Engineers Comments Regarding Surface Water Drainage

Application Reference:	P/46/25/DOC	Reviewer Reference:	ADC/SB
Planning Officer:	Jessica Riches	Date of Review:	30/07/2025
Site Name:	Land South of Summer Lane and West of Pagham Road Pagham		
Application Description:	Approval of details reserved by condition imposed under reference P/140/16/OUT relating to condition number 4 - detailed scheme of phasing , condition number 5 - schedule of materials and finishes, condition number 17 - Construction Management Plan and condition number 24 - energy.		
Assessment Number:	1 of 2

Condition 4: Objection

Preliminary access drainage reliant upon Drainage Phase A.

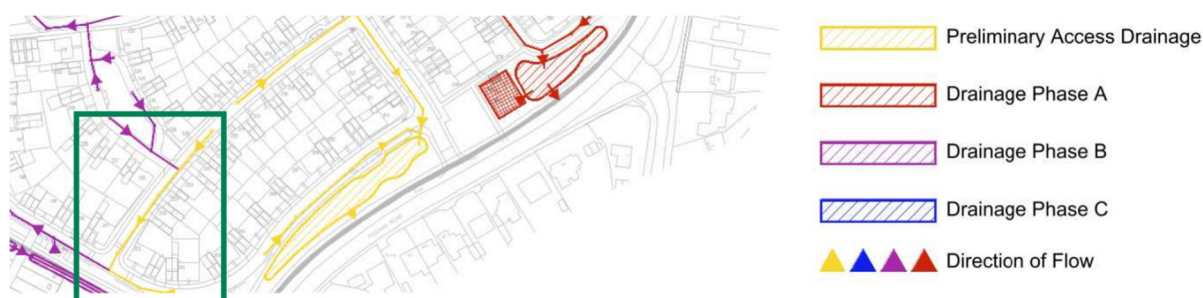
The DPP shows that parts of the preliminary access drainage are reliant on later phases drainage network, storage and outfall. Illustrated in two snips below:

Drainage Phase B reliant upon Drainage Phase C.

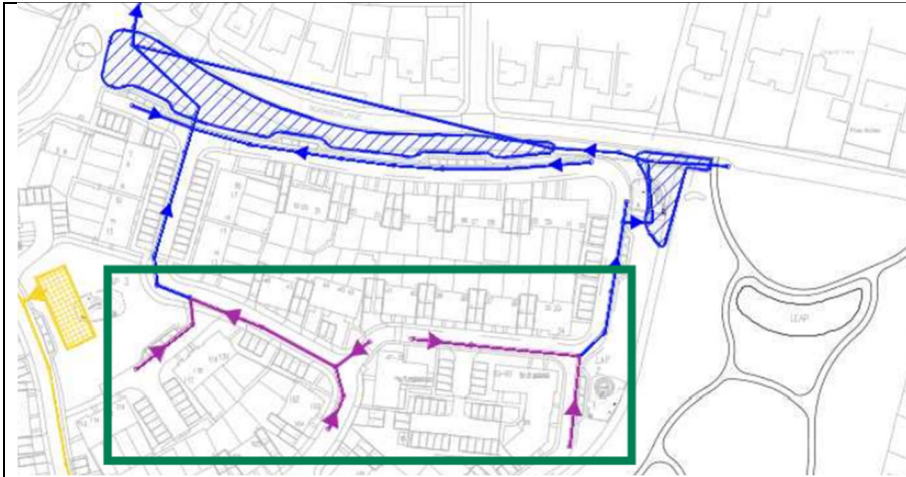
The same plan also shows that two parts of Drainage Phase B are reliant upon the construction of the network, storage and outfall for Drainage Phase C:
